[Docket No. FAA–2018–0804; Product Identifier 2018–NM–129–AD; Amendment 39–19442; AD 2018–20–08]

Airworthiness Directives; Airbus SAS Airplanes

2018–20–08 Airbus SAS: Amendment 39– 19442; Docket No. FAA–2018–0804; Product Identifier 2018–NM–129–AD.

Figure 1 to paragraphs (h) and (i) of this AD – *AFM procedure continued*

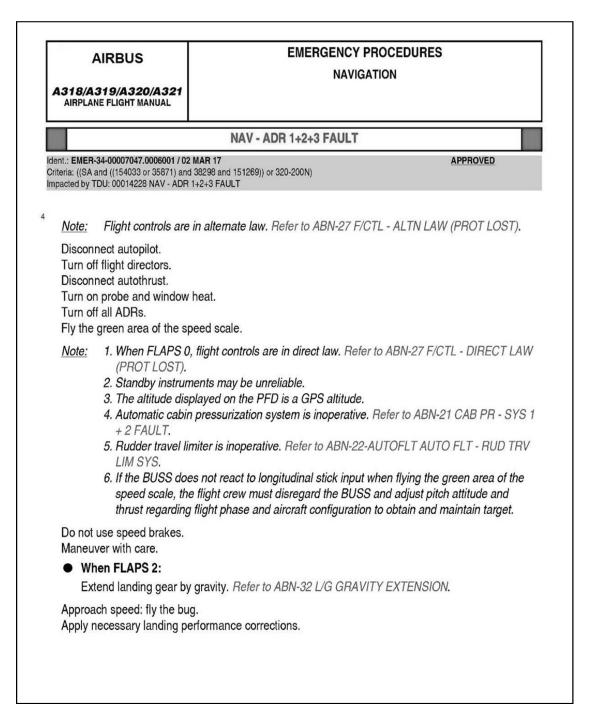
(1) For Group 1 airplanes, except for airplanes identified in paragraph (i) of this AD: Within 30 days after the effective date of this AD, revise the AFM to incorporate the procedure specified in figure 1 to paragraphs (h) and (i) of this AD.

(2) For Group 2 airplanes: Within 30 days after the effective date of this AD, revise the AFM by removing the procedure specified in figure 1 to paragraphs (h) and (i) of this AD from the AFM.++

Airplanes operated with an AFM having the NAV–ADR 1+2+3 FAULT procedure identical to the procedure specified in figure 1 to paragraphs (h) and (i) of this AD, with an approval date on or after March 2, 2017, are compliant with the requirements of this AD, provided that the procedure is not removed from the AFM.
